# **AIA® Document G701™ – 2017**

## Change Order

**PROJECT:** (Name and address)  
Williamson County  
Animal Shelter Expansion  
1855 SE Inner Loop  
Georgetown, TX 78626

**CHANGE ORDER INFORMATION:**  
Change Order Number: 004

**Section:**  
**SK-1 ELKAY**

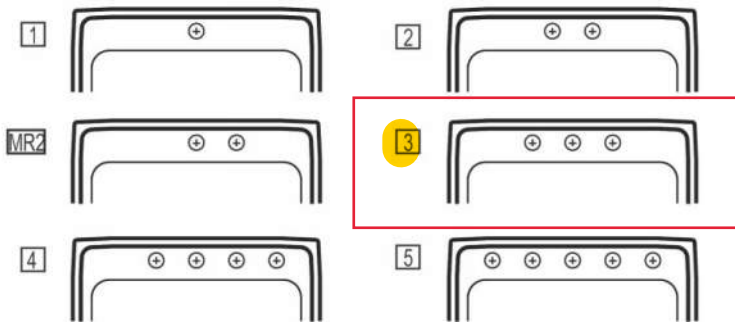
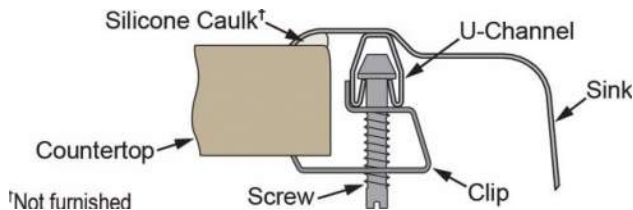
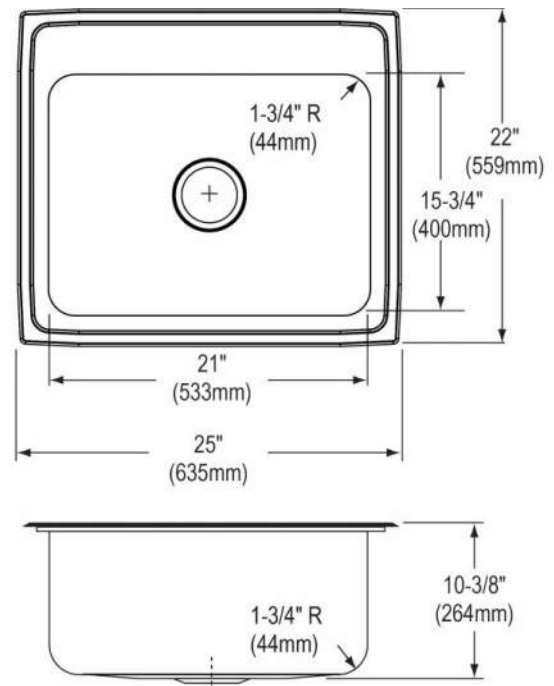
Per Architect drawing for room 106 shows stainless counter top going in but per plumbing drawings it doesn't show faucet type for the room.

Prepare the new stainless steel countertop for room 106 for sink fixture 'SK-1,' to align generally with the existing tie-in location. See the 'SK-1' Product Data from reviewed submittal 224000-1-1, dated 04/11/18, attached for immediate reference.

P.3-3.02

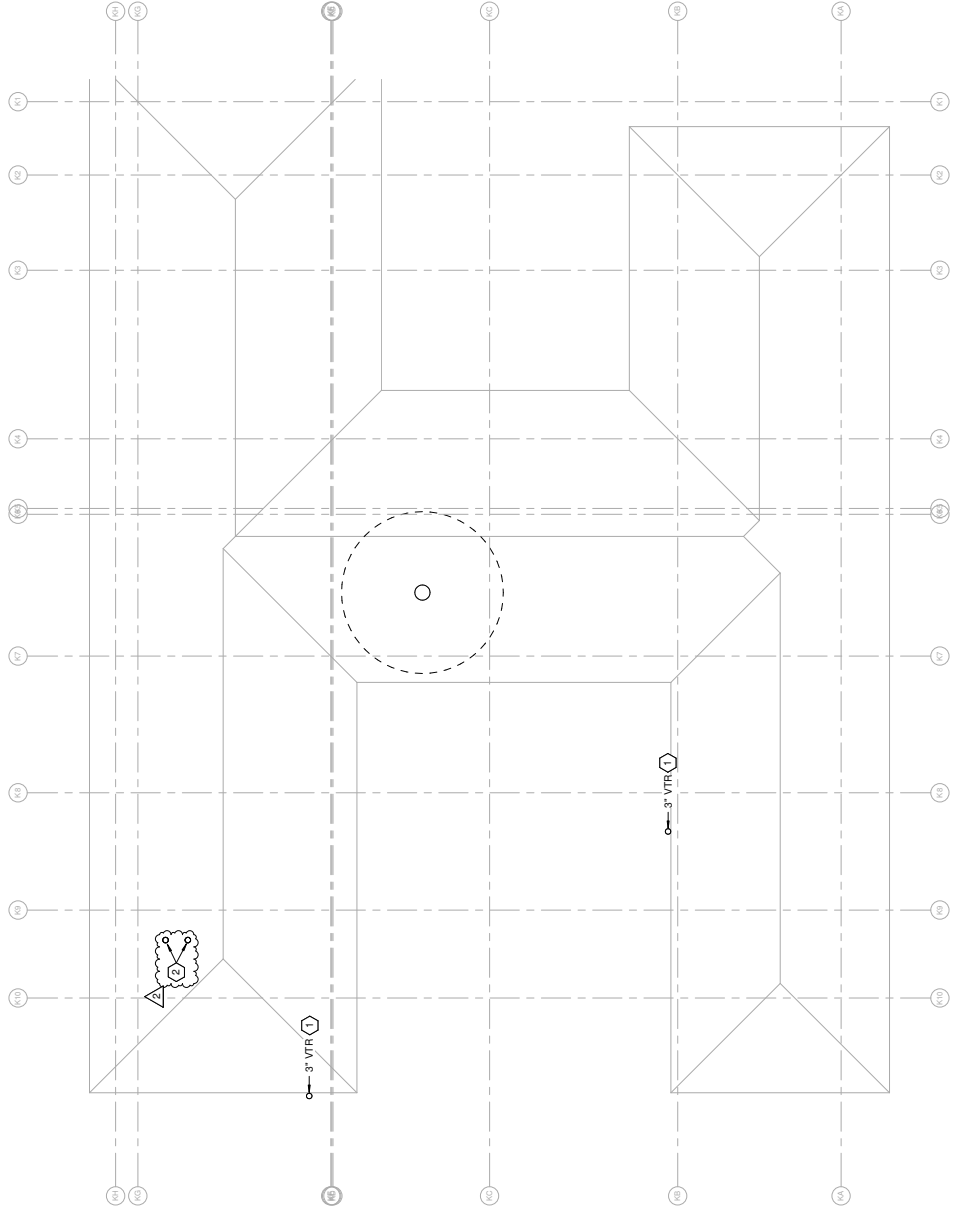
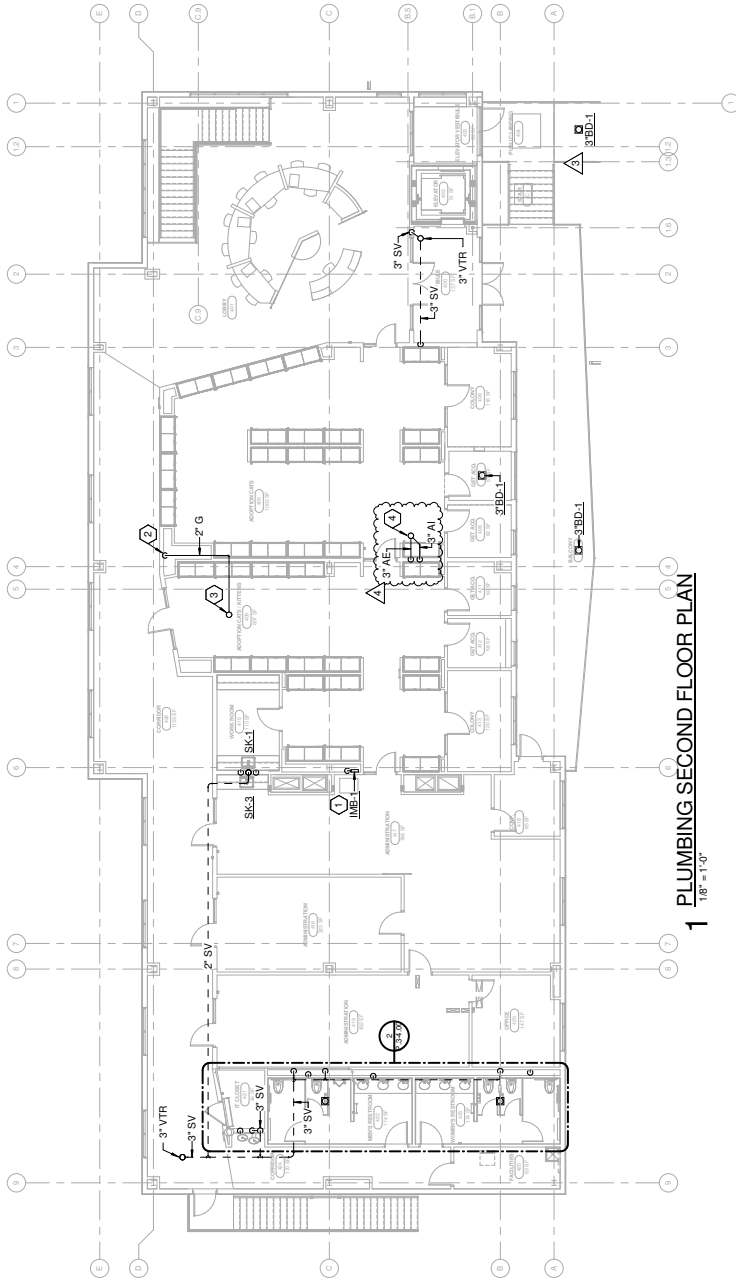
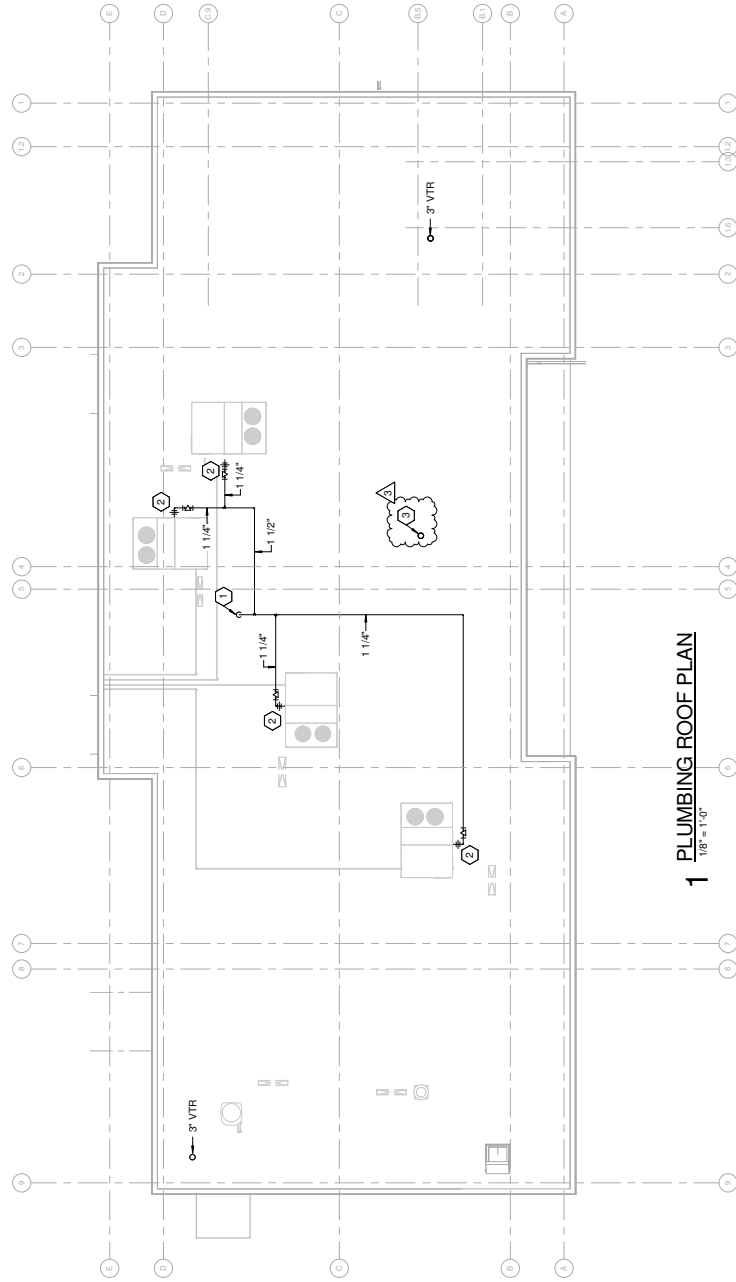
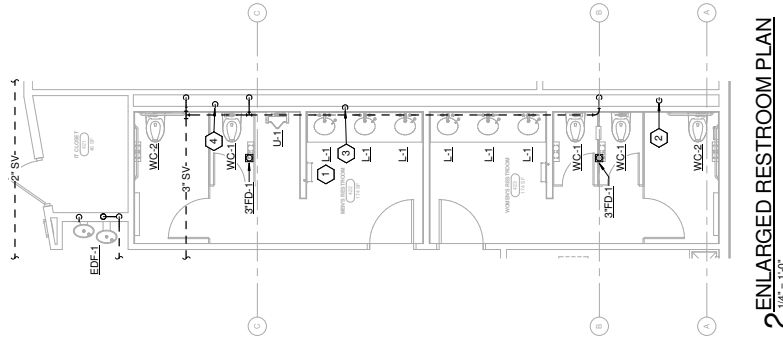
P.3-3.01 shows the location of the Gas Water Heater but does not show air supply/vent pipes for 1st/2nd floor or the roof on P.3-3.02 and P.3-3.03. The only roof vents shown are the two 3" sewer lines. The water heater requires two 3" PVC pipes for supply and ventilation.

Please provide a route for the Gas Water Heater air supply/vent pipes

See attached revised drawings P0.01, P.2-3.01, P.3-3.02, P.3-3.02, P.3-3.03, and P.3-4.00 for gas water heater combustion air supply and vent pipe routing.

- 1 ROUTE 2 NATURAL GAS SUPPLY FROM BELOW.
- 2 ROUTE 1 1/4" NATURAL GAS SUPPLY TO NEW MECHANICAL UNIT. PROVIDE HARD-PIPED CONNECTION WITH 6" DIRT LEG, LUBRICATED PLUG VALVE, AND DIELECTRIC UNION.
- 3 3" CONCENTRIC VENT TERMINATION FOR GWH-1 FLUE AND COMBUSTION AIR INTAKE.
